From: Franzone, Steve [<mailto:Steve.Franzone@fpl.com>]
Sent: Monday, September 24, 2012 2:33 PM
To: Comar, Manny
Cc: Franzone, Steve; Maher, William; Burski, Raymond
Subject: DRAFT RAI Responses FPL Turkey Point 6 & 7 for eRAI 5896 Basic Geologic and Seismic Information

NRC RAI Letter No. PTN-RAI-LTR-037

NRC RAI Number: 02.05.02-3 (eRAI 5896)

NRC RAI Number: 02.05.02-5 (eRAI 5896)

New Caribbean Model Geometry

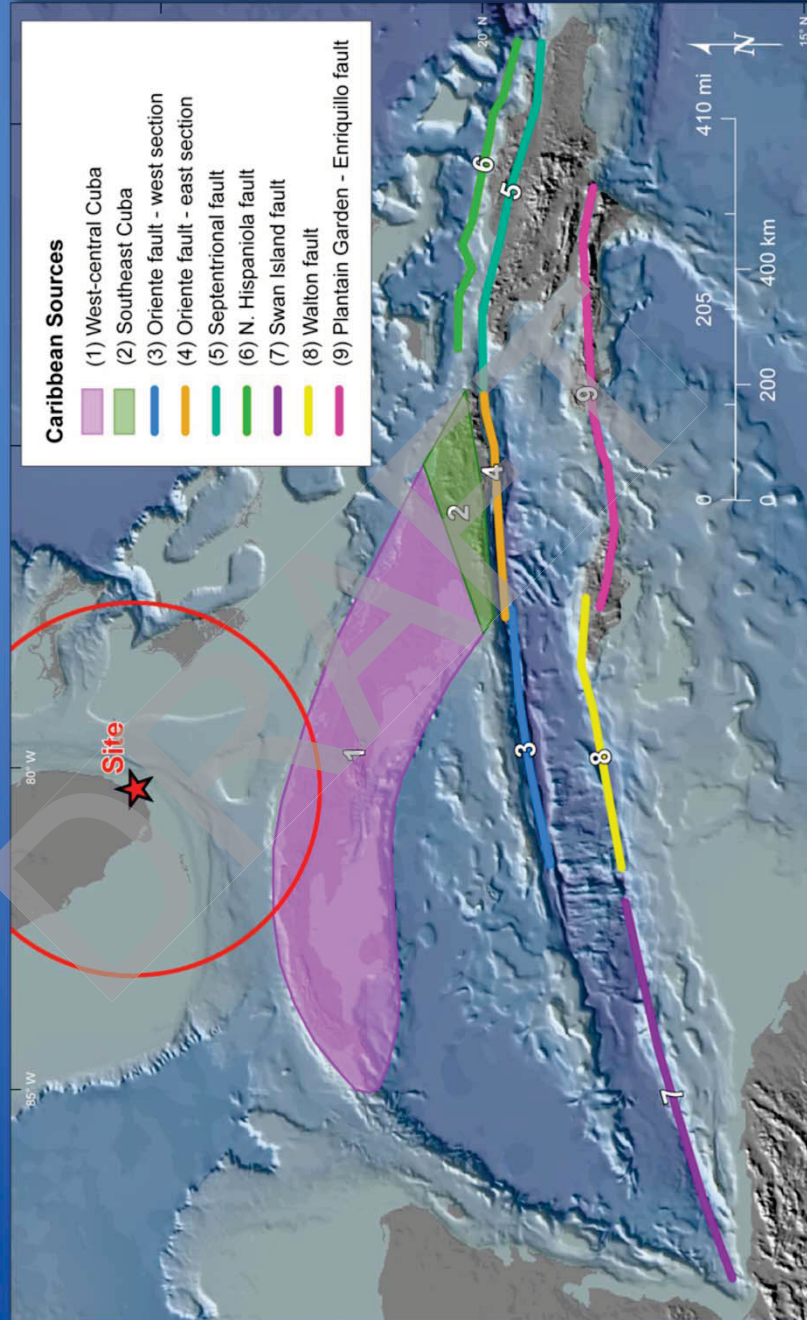
As a preliminary "straw man" model, we have identified the following six seismic sources in the northern Caribbean region as relevant to seismic hazard in southern Florida (see attached figure):

It is our assessment that faults in Cuba are not sufficiently characterized to warrant fault (line) sources. The source zone boundaries for Cuba are defined by tectonic landforms, geology, and seismicity (see figure).

Figure 1. Comparison of converted magnitudes for the complete modified Phase 2 catalog: FSAR vs. CEUS SSC (EPRI et al., 2012). This figure represents the M_w correlation among 10,747 events.

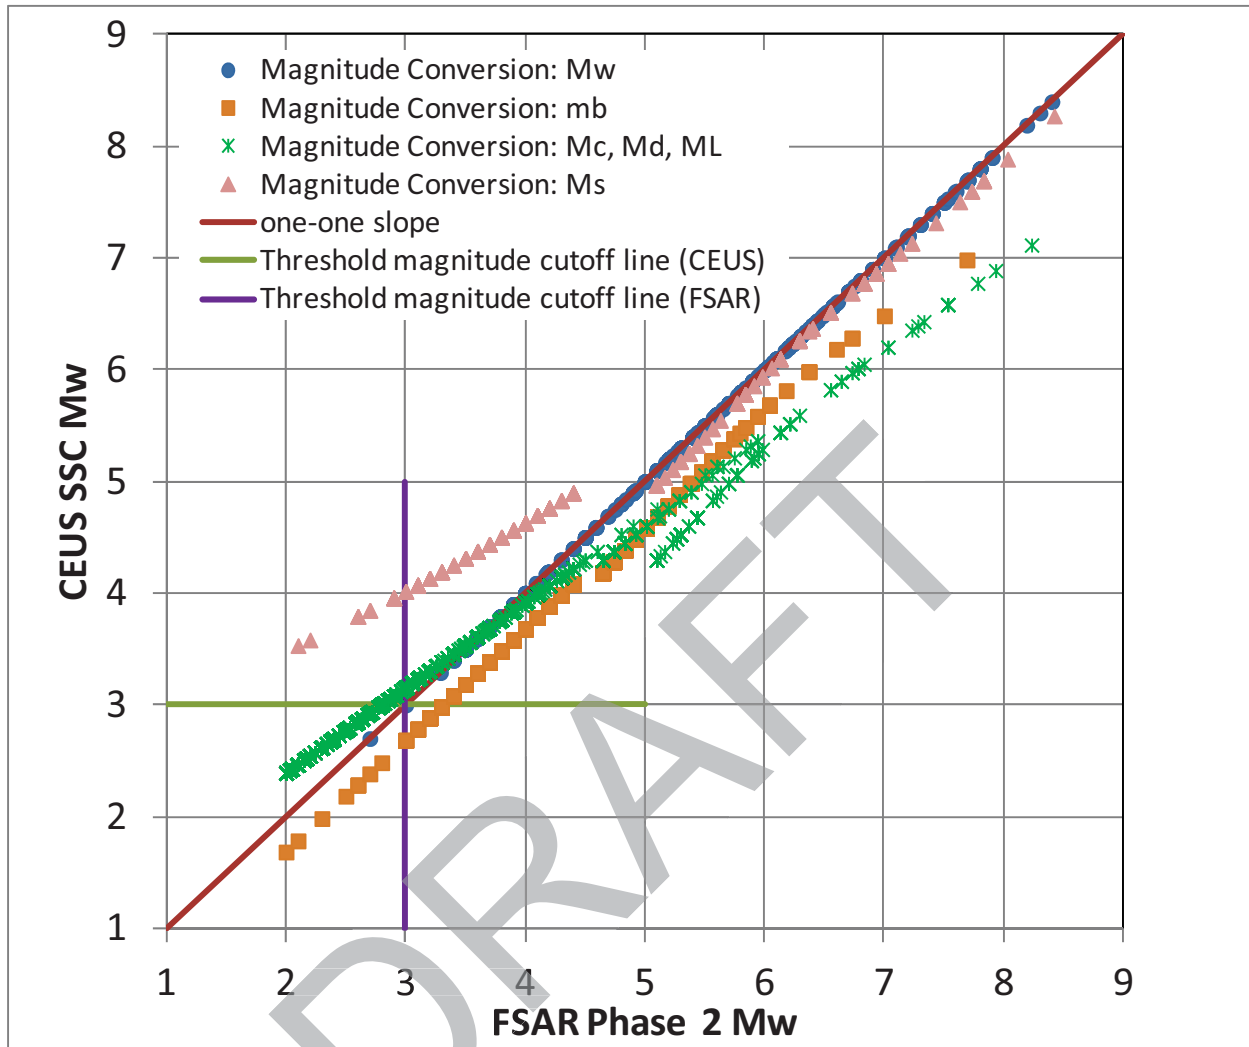
FSAR Subsection 2.5.2.1.3.1 states that M_w was used as the uniform magnitude measure in Phase II (Caribbean region) earthquake catalog development efforts. Phase I earthquake catalog (EPRI updates), on the other hand, uses m_b as the uniform magnitude measure. In accordance with NUREG-0800, Standard Review Plan, Chapter 2.5.2, "Vibratory Ground Motion," and Regulatory Guide (RG) 1.208, "A Performance-Based Approach to Define the Site-Specific Earthquake Ground Motion", please explain the rationale for selecting M_w as the uniform magnitude measure for the Caribbean earthquake catalog rather than m_b . Discuss what impact, if any, this choice had on the number of earthquakes listed in the Caribbean earthquake catalog. Were there any earthquakes with m_b of 3.0 (or perhaps larger) that did not make the $M_w \geq 3.0$ cut used in Phase II catalog development?

leads to a smaller estimate of moment magnitude than considered in the FSAR – see Figure 1. For example, if the CEUS-SSC magnitude conversion relations had been considered for the Phase 2 catalog, the moment magnitude equivalent to m_b 3.0 would be about M_w 2.7, instead of the M_w 3.0 in the FSAR.

Figure 1 indicates that for about M_w 3.5 and greater, the CEUS SSC leads to smaller converted M_w magnitudes, notably so for the largest magnitudes. For M_w less than about 3.5 the CEUS SSC magnitude conversions lead to slightly larger M_w magnitudes. Further, considering the intent of presenting the Phase 2 catalog as M_w 3.0 and greater, the CEUS SSC magnitude conversions would add some additional events which the FSAR catalog would have considered M_w 2.8 to 3.0.

leads to very similar estimates of moment magnitude for earthquakes larger than 4.5 as those that were considered in the FSAR (FSAR 2.5.2) – see Figure 1. For the relatively few events with M_s less than 4.5 in the Phase 2 catalog, the CEUS SSC magnitude conversion leads to larger M_w magnitudes than the conversion assumption of equivalence in the FSAR.
